## FRONT CAP BADGE REPAIR

<b>Bulletin Type:</b>	TSB	<b>Publication Date:</b>	August 2023
<b>Bulletin #(s):</b>	23-113	<b>Make(s):</b>	Jayco
<b>Job Code(s):</b>	9801589	<b>Model(s):</b>	Eagle FW, Eagle HT FW
<b>Flat Rate(s):</b>	9801589A .10 HR Inspection of Front Cap Badge 9801589B 1.0 HR – Front Cap Badge Inspection and Repair	<b>Model Year(s):</b>	2024

<b>Incident:</b>	Debris/dirt behind front cap badge
<b>Affected Units:</b>	2024 Jayco Eagle FW, Eagle HT FW
<b>Parts Kit:</b>	Parts Kit #: 23-113JT
	8 Ft - SEAL,WDO .63X.38 RIB W/ADH BK 1 Tube - SEALANT,GEOCEL CLR 2300 VBS 10Pcs - NUT,HEX LK NYL ZINC 8-32 20 Pcs - WASHER,NEOBOND GALV #14X1.00
<b>Misc. Tools &amp; Supplies:</b>	Screwgun #2 sq bit 9mm socket 3/32" drill bit Torque wrench
<b>Parts Return Information:</b>	N/A

Fig. 2

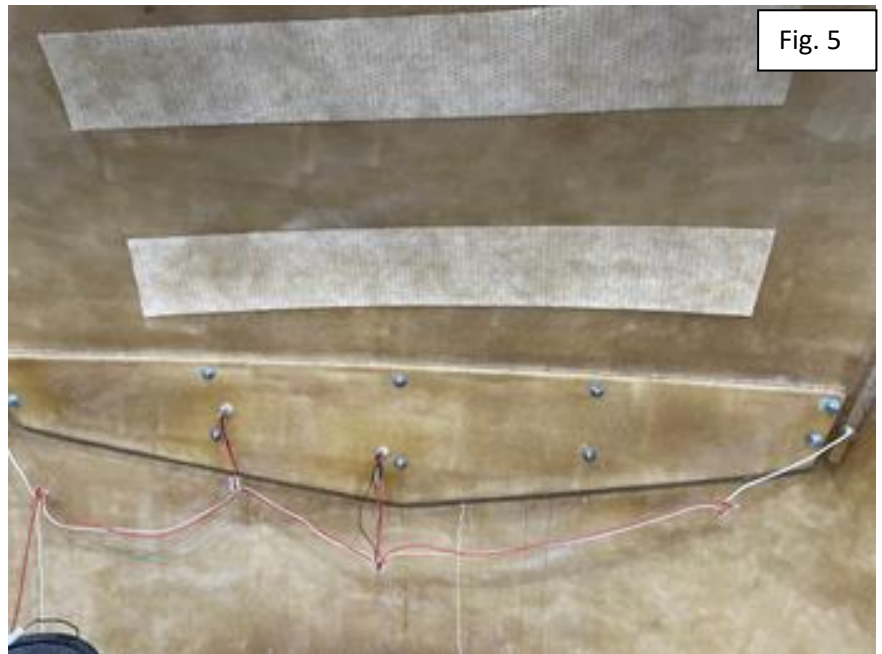
1. Go inside coach and remove insert in front bedroom. (Figure 2)
  - a. Note: Insert may vary based on floorplan.

Fig. 11

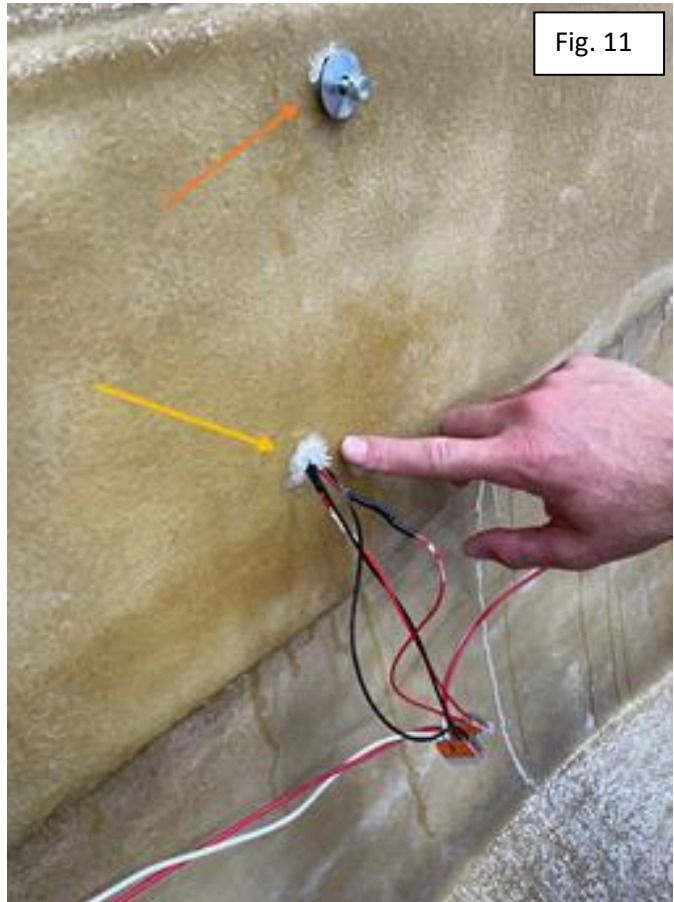
- 10. Ensure wires are pulled back through the cap and that washers are placed back on the studs. Reinstall nuts at 8 in./lbs. Reseal the wire holes using geocell 2300. (Figure 11)

Fig. 13

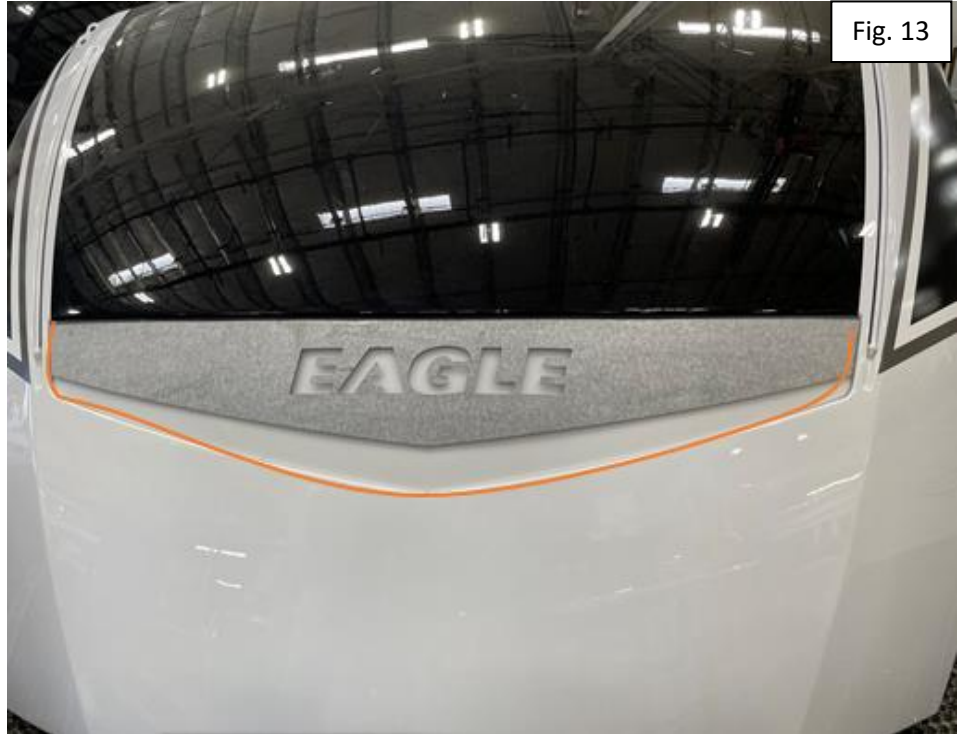
12. Diagram showing seam location. (Figure 13)
